Project Name: * R-5014-Widening of SR1217 from dead end to US158

Subject: **Request for Minor Modification of the CAMA Major Development Permit** for the widening of SR 1217 (Colington Road) from Dead End to US 158 (Croatan Highway) in Dare County, North Carolina; TIP Project R-5014, Federal Aid Project No. STP-1217(6); Debit \$100 from WBS Element 41162.1.1

Reference: CAMA Major Development Permit #125-18 issued November 5, 2018

The NCDOT is requesting a Minor Modification for CAMA Major Development Permit #125-18.

PERMIT DRAWING
SHEET 16 OF 41

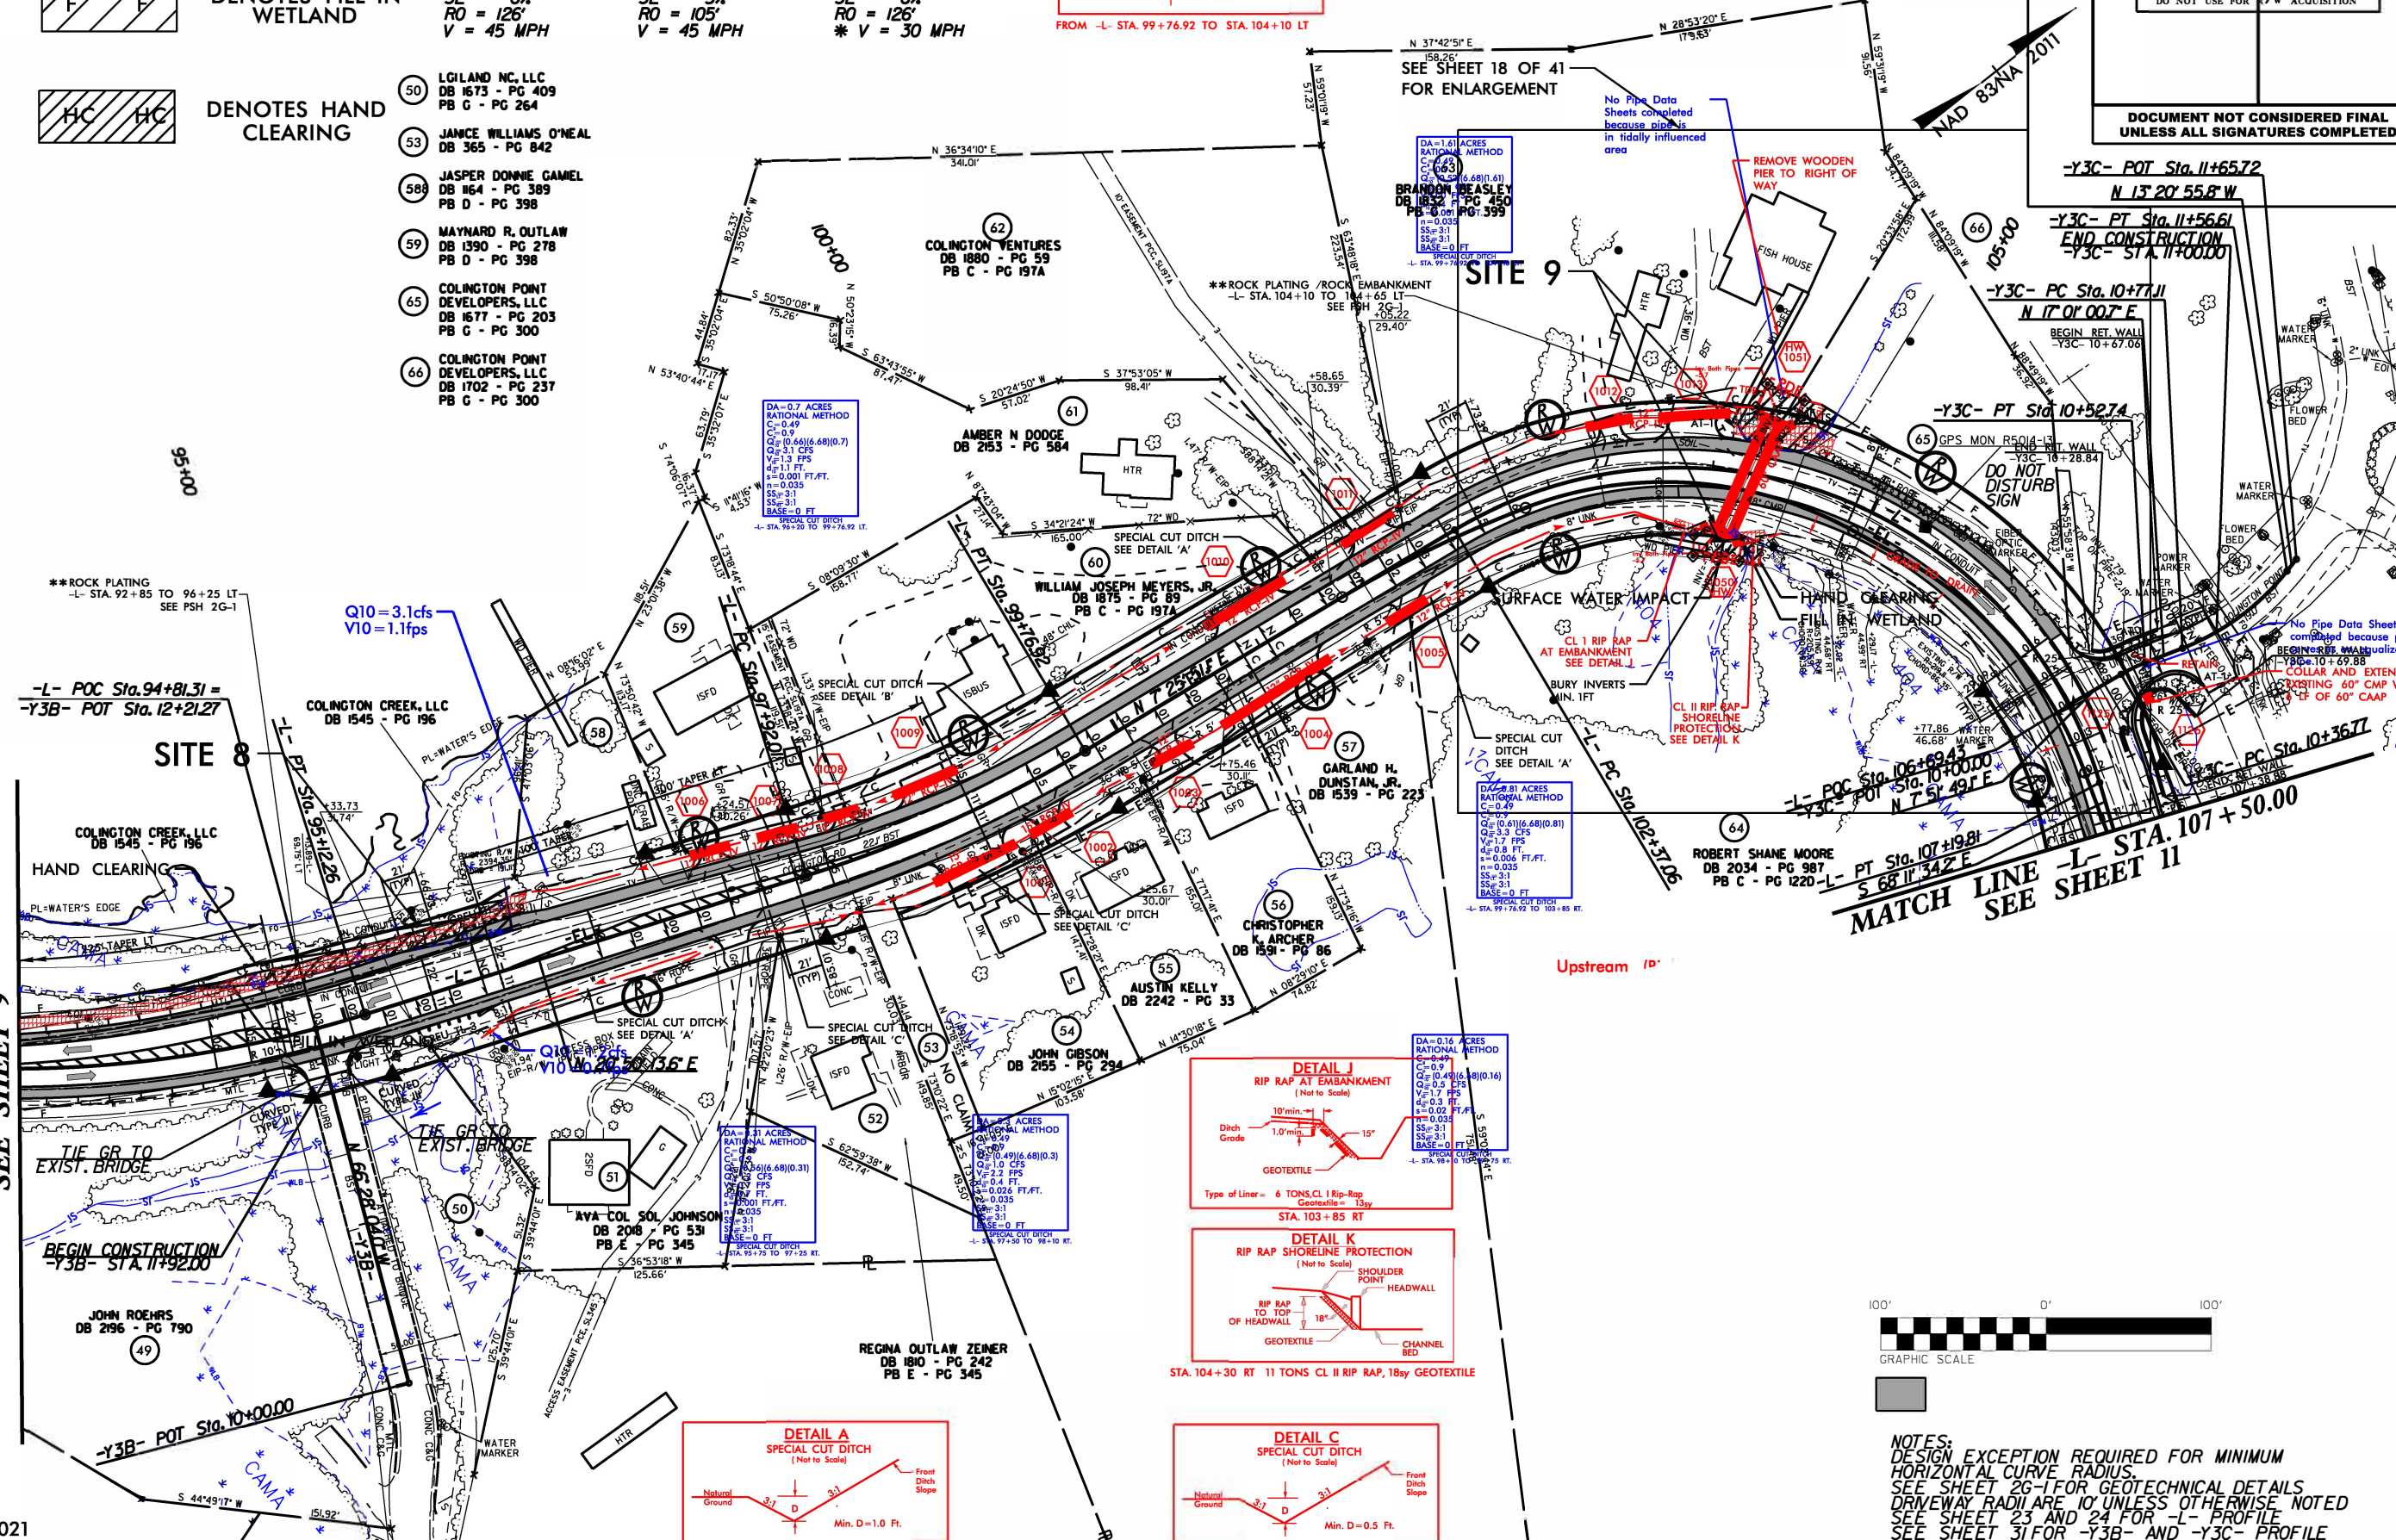
- Site 2** 56+30 to 56+75 LT, rock embankment / rock plating
SW fill reduced to <0.01. Perm. channel impact increased to 32 lf.
- Site 9** 104+10 to 104+65 LT, rock embankment / rock plating
SW fill reduced to 0.01 ac., Permanent channel impact added totaling 78 lf (55 lf stabilization).
- Site 12** 126+70 to 127+55 LT, rock embankment / rock plating
SW fill increased slightly an additional <0.01 ac., Permanent channel impact added 71 lf (all stabilization).

FROM -L- STA. 99+76.92 TO STA. 104+10 LT

PERMIT DRAWING
SHEET 17 OF 41

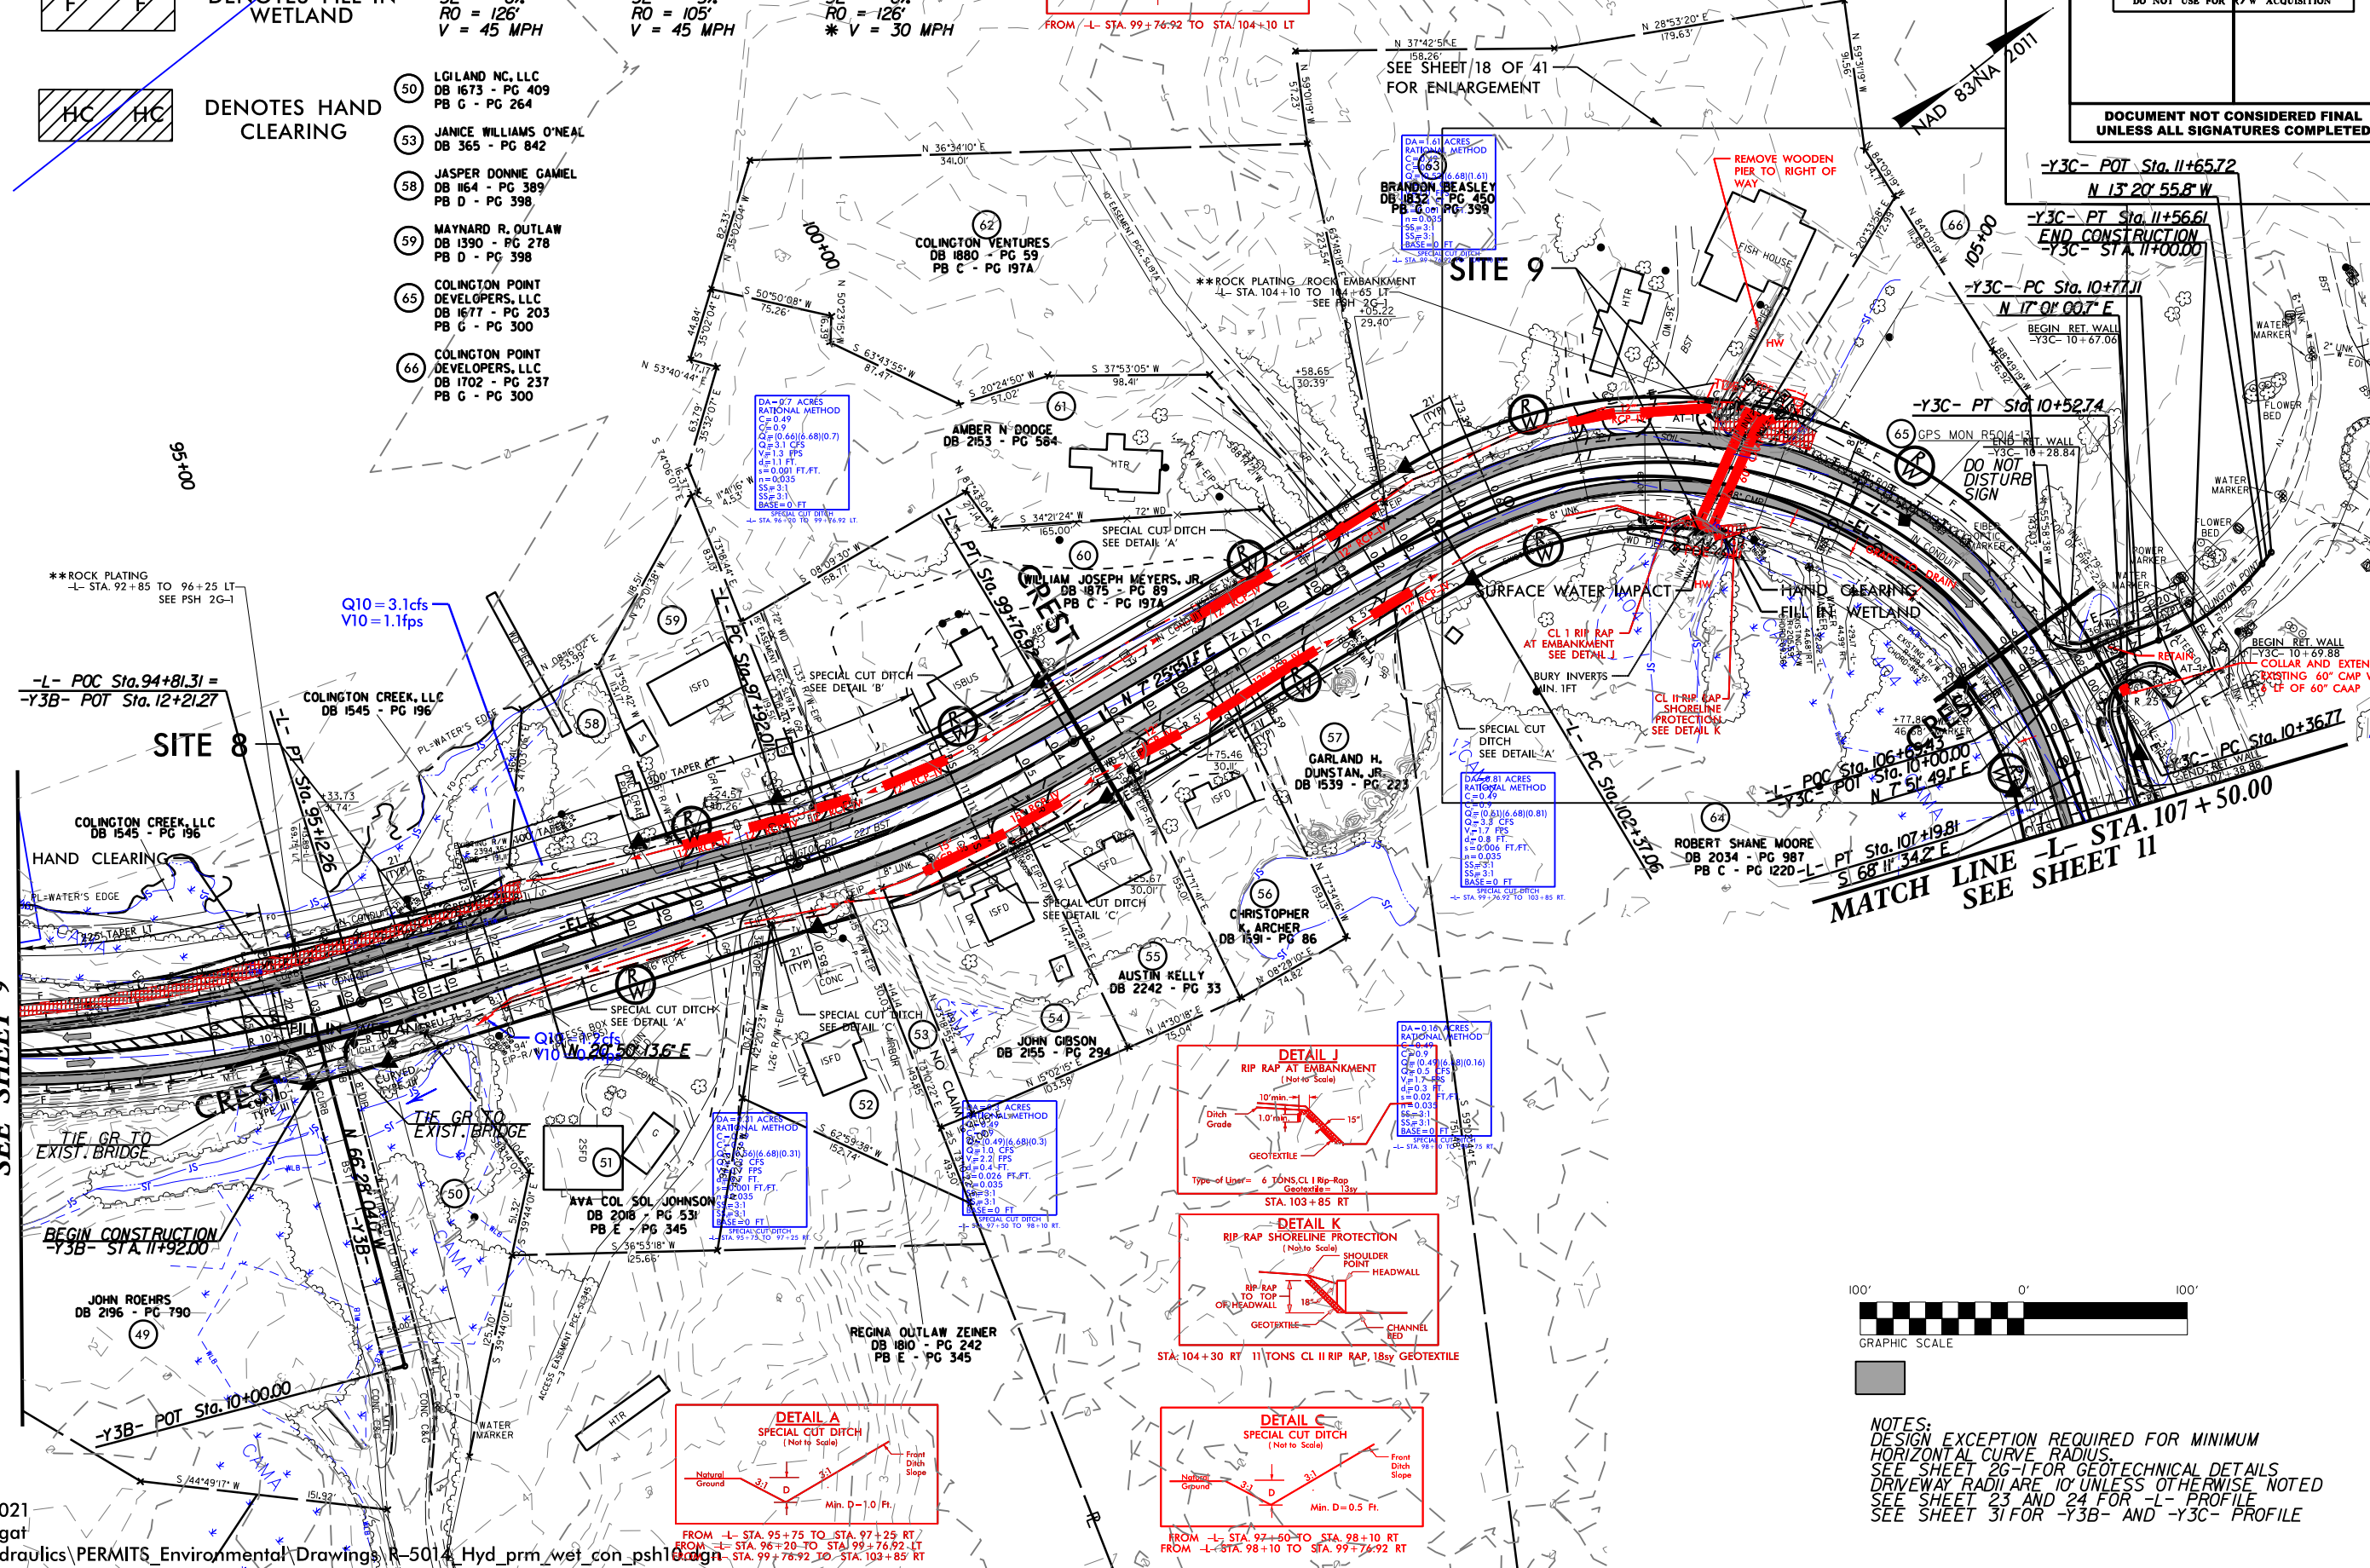
Site 8 92+85 to 96+25 LT, rock plating

PERMIT DRAWING
SHEET 31 OF 41

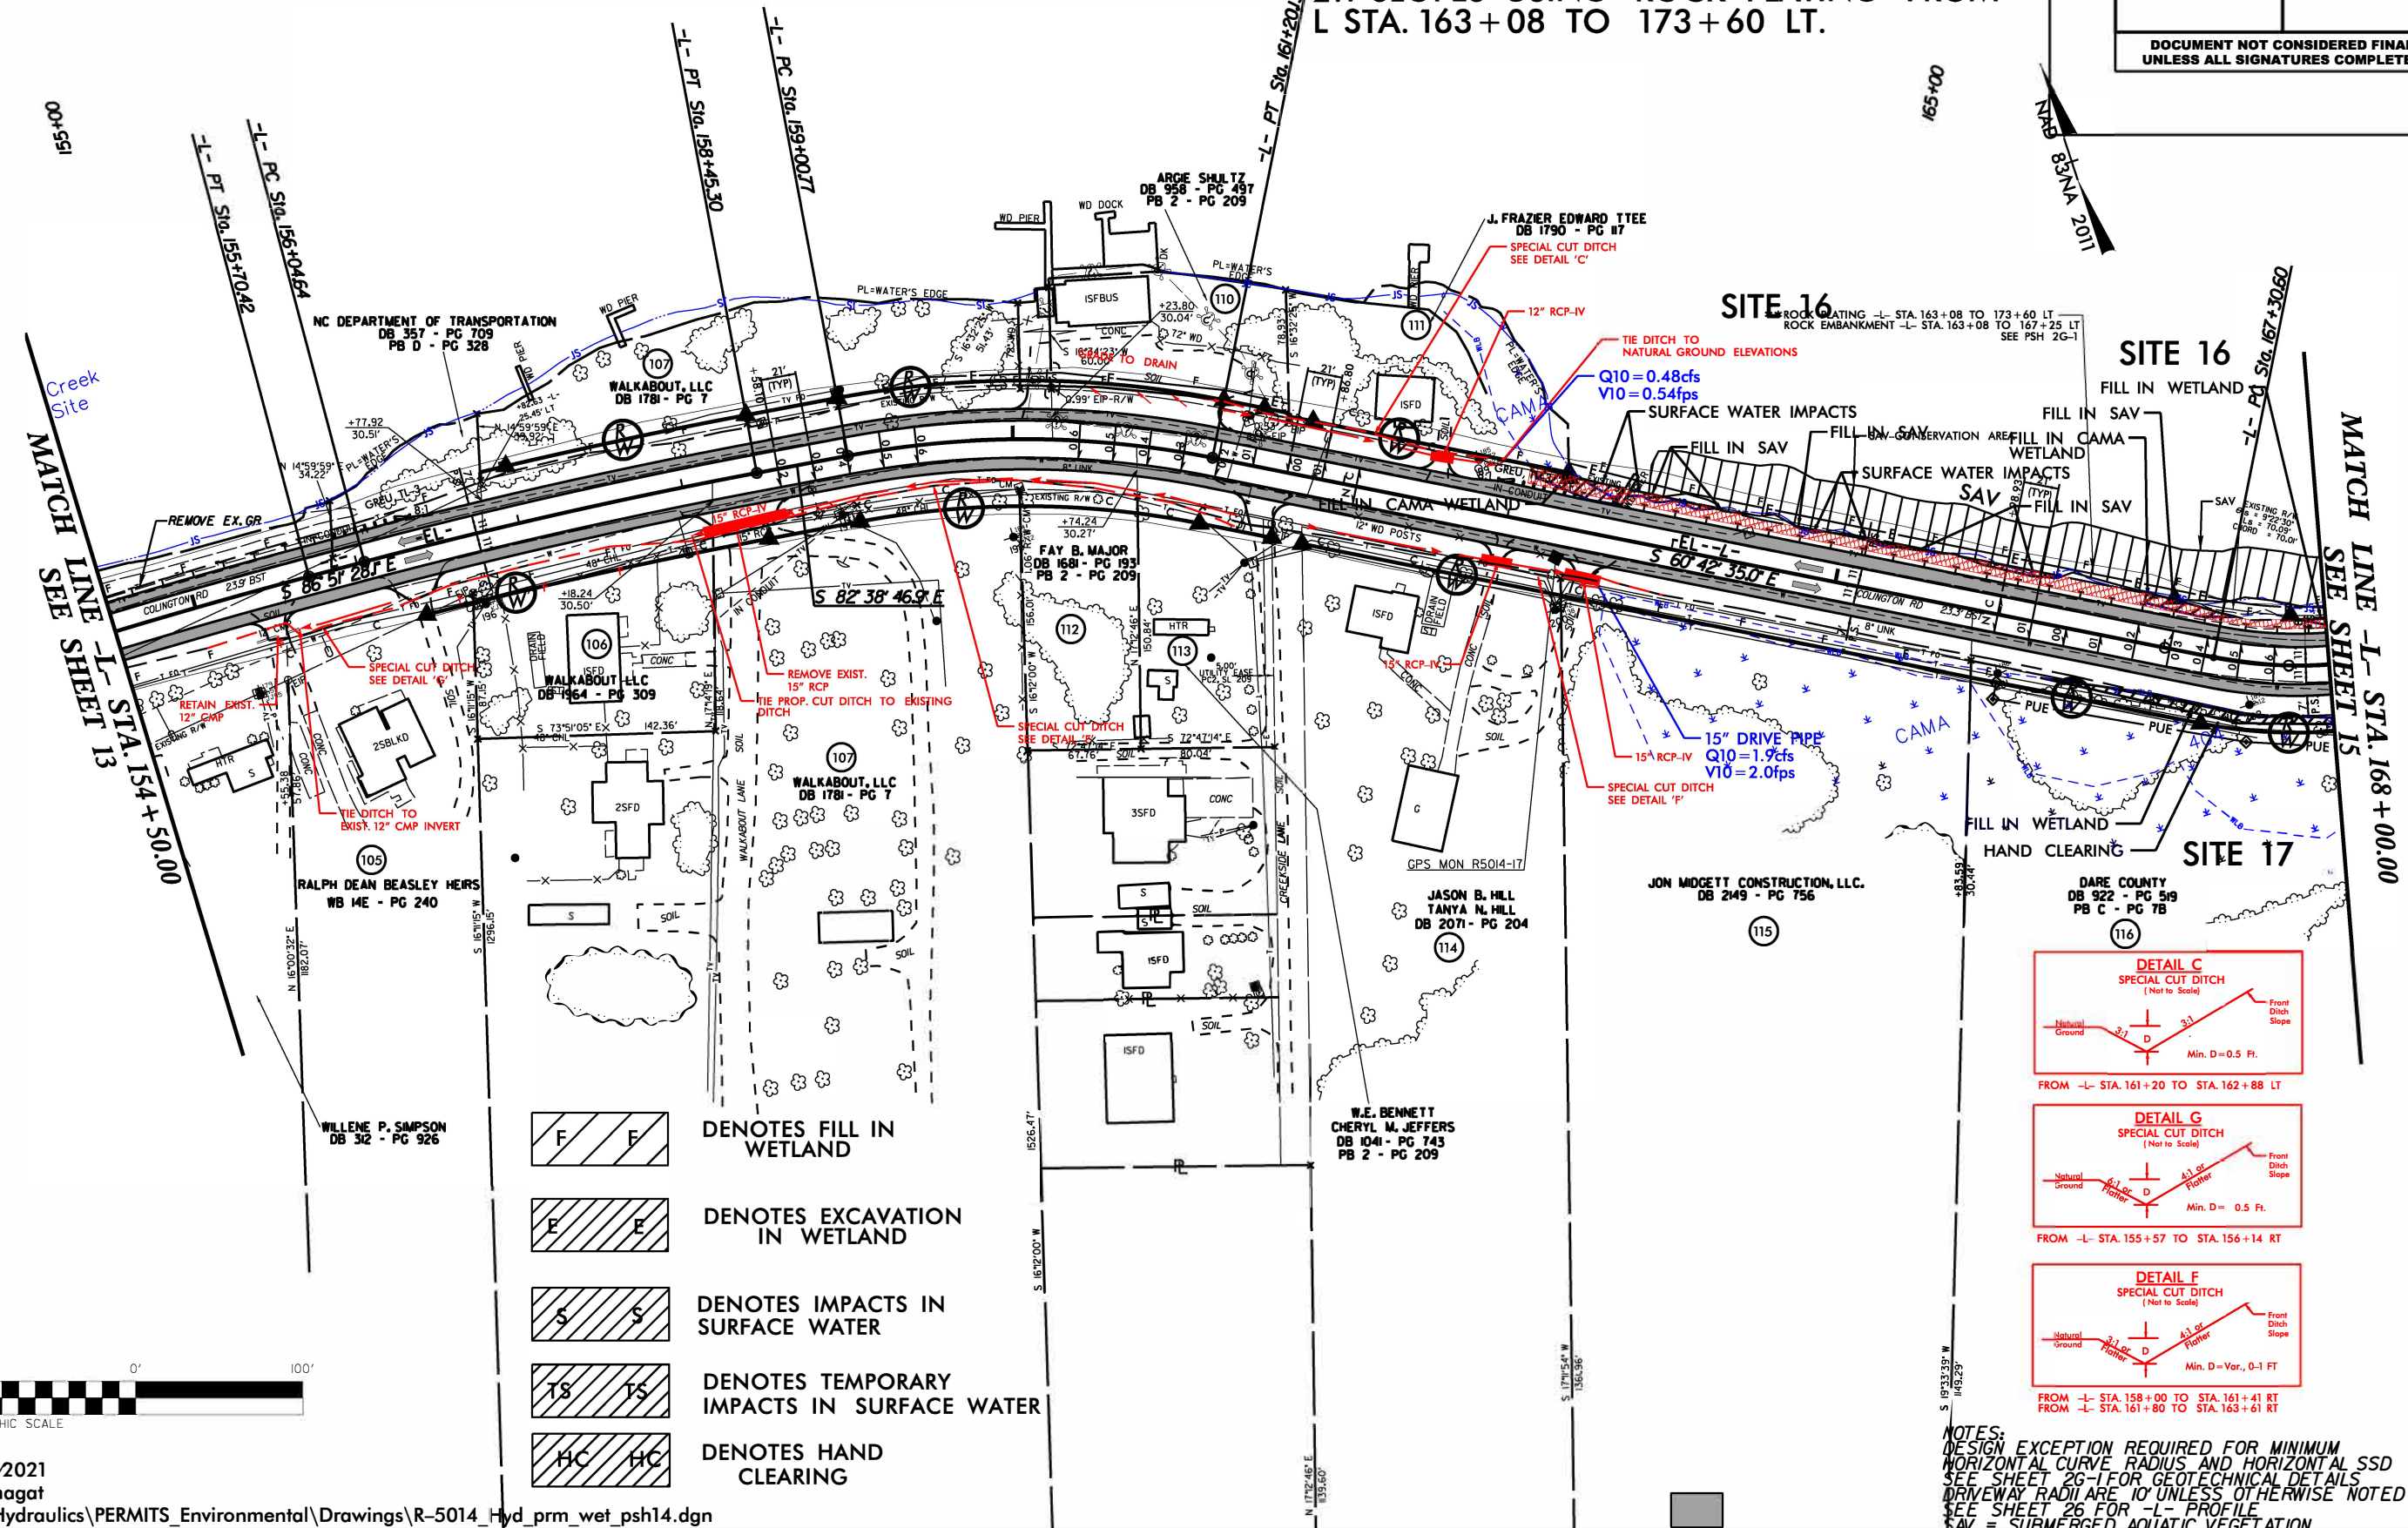
Sites 16 & 18 163+08 to 173+60 LT, rock embankment / rock plating

2:1 SLOPES USING ROCK PLATING FROM
L STA. 163+08 TO 173+60 LT.
